Access Compliance Report

Public Rights-of-Way

(Curb Ramps)

Intersection ID: 48634	Main Street: GRANDE_HEIGHTS_DR	Cross Street: DOMINION_CREST_DR	Location: NW
ADA ID: E1E8D79CC746	Ramp Type: Perp	Initial Pass/Fail: Fail	Overall Compliance: No
Severity Score: 8.75			
Codes/Mitigation Info/Possible Solution		Field Measurements/Component Compliance

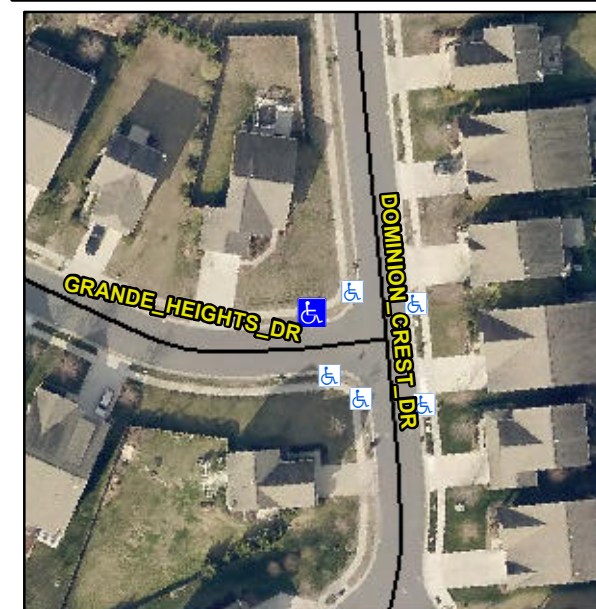
Compliance	Description	Data	Compliance	Description	Data
N/A	Ramp Length (in)	47.0	Yes	Ramp Slope (%)	5.7
No	Ramp Width (in)	46.5	Yes	Ramp XSlope (%)	0.9
N/A	Flare Type LT	N/A	N/A	Flare Type RT	N/A
N/A	Flare Slope LT (%)	N/A	N/A	Flare Slope RT (%)	N/A
N/A	Flare Traversable LT?	N/A	N/A	Flare Traversable RT?	N/A
N/A	Landing Length (in)	N/A	N/A	DWS Provided?	N/A
N/A	Landing Width (in)	N/A	N/A	DWS Contrast?	N/A
N/A	Landing Slope (%)	N/A	N/A	DWS Length (in)	N/A
N/A	Landing X Slope (%)	N/A	N/A	DWS Full Width?	N/A
N/A	Landing Curb? (Y/N)	N/A	N/A	DWS Offset (in)	N/A
N/A	Shared Landing?	N/A			
N/A	Gutter Ponding?	N/A	N/A	Gutter Slope (%)	N/A
N/A	Gutter Lip Ht (in)	N/A	N/A	Gutter X Slope (%)	N/A
N/A	Painted X Walk1?	No	N/A	Painted X Walk2?	N/A
	X Walk 1 Direction	To S		X Walk 2 Direction	N/A
N/A	X Walk 1 Width (in)	N/A	N/A	X Walk 2 Width (in)	N/A
	X Walk 1 Slope (%)	0.9		X Walk 2 Slope (%)	N/A
	X Walk 1 X Slope (%)	0.3		X Walk 2 X Slope (%)	N/A

N/A	Ramp inside XWalk1?	N/A	N/A	Ramp inside XWalk2?	N/A
	Road Slope (%)	N/A	N/A	Clear Space?	N/A
	Road X Slope (%)	N/A	N/A	Clear Space to XWalk (in)	N/A
N/A	Any Obstructions?	N/A	N/A	Storm Grate/Utility Hazard?	N/A
	Obstruction Type			Storm Grate/Utility Type	
		N/A			N/A
			Yes	Surface Condition? (G/P)	Good

Remove & Replace Entire Ramp.
